**Report to the Future Melbourne (Planning) Committee**

**Ministerial Referral: TPM-2017-13, Two Melbourne Quarter (Stage C3),  
681-691 Collins Street, Docklands**

17 October 2017

## PLANNING REPORT MINISTERIAL REFERRAL

**FIGURE 7: DIAGRAM SHOWING ENCROACHMENT OF DP BUILDNG ENVELOPE**

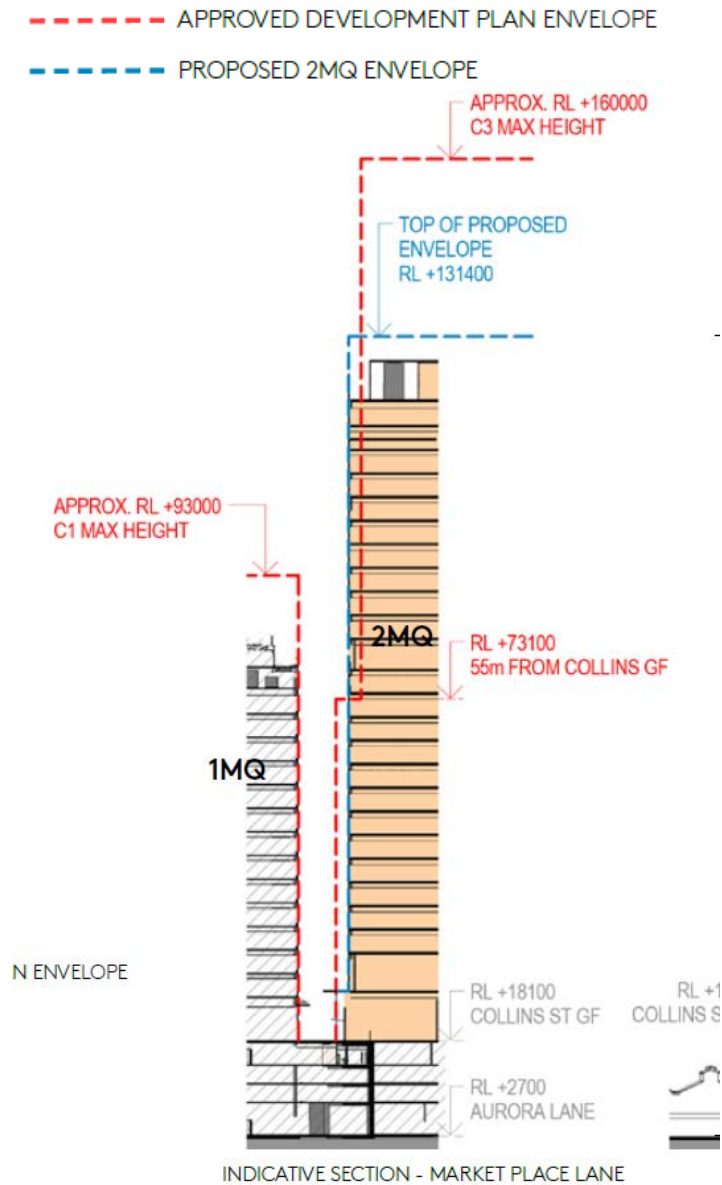
The proposed development is considered to be generally in accordance with the DP including the DP Amendment. The proposal is generally in accordance with the maximum building envelopes and heights, envelopes plan, land use table and the public realm including the Melbourne Square and Aurora Lane. The only potential exceptions to this is the encroachment beyond the envelope as shown in Figure 7 below and the location of the community space. The encroachment is considered modest and of limited impact given the building is now setback further from One Melbourne Quarter at the lower levels where the two buildings face one another. Furthermore, the maximum height of One Melbourne Quarter is multiple storeys below what was envisaged as part of the Development Plan. Consequently the impact is less given that separation is increased for every habitable floor of One Melbourne Quarter. The slight reduction in separation above One Melbourne Quarter is considered less critical and far less impactful on either building and as such the moderate change to the envelope is still deemed generally in accordance with the DP.

‘An 8m setback between One Melbourne Quarter (C1) and Two Melbourne Quarter is proposed where the Development Plan calls for a 10m setback. The intent of this setback is to provide tower separation between the two buildings at the upper levels. Given One Melbourne Quarter will not be constructed to the full height contemplated in the Development Plan, and it only extends for one level above height datum where the 8 metre tower setback, the proposed outcomes are acceptable.’
